Memo

Subject: DA2021/1522 – 189 Riverview Road, Avalon Beach

On 2 February 2022, the Northern Beaches Local Planning Panel (**NBLPP**) reviewed DA2021/1522 for demolition works and the construction of a dwelling house (**the application**) at 189 Riverview Road, Avalon Beach (**site**).

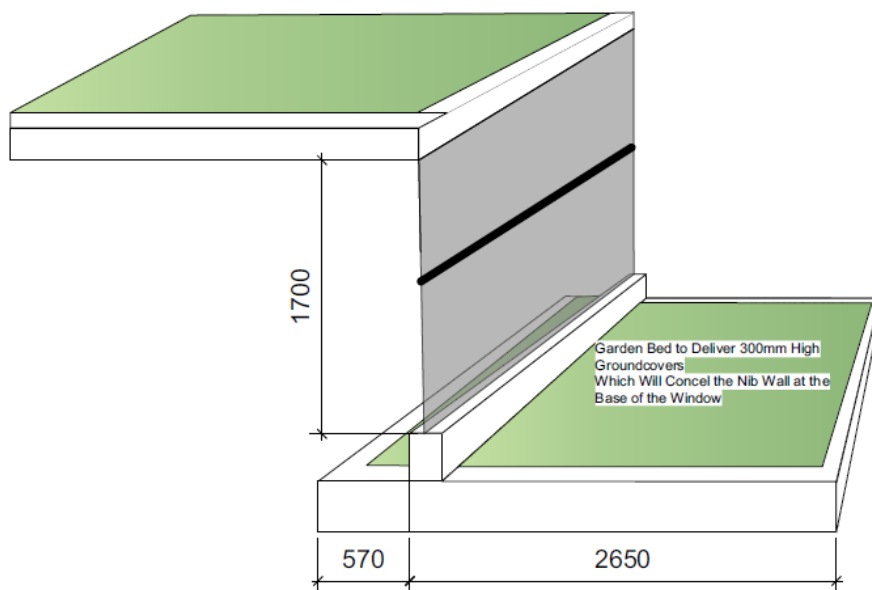
3. **Clarification.** *The applicant is requested to provide by 16 February 2022 updated Site, Floor, Landscape and Northern Elevation Plans clarifying the location of the external stairs, inclinators, their respective landings and the supports for the proposed inclinators, including the location of same in relation to Tree 27; and details of such supports including materials, dimensions, and whether they are in the location of the sub-root zones of trees that are to be retained.*

Comment: The applicant has provided a revised northern elevation, site plan, landscape plan and additional construction details of the main living room clerestory windows. The plans show details of the proposed inclinator, including footing locations and the structures relationship to Tree T27.
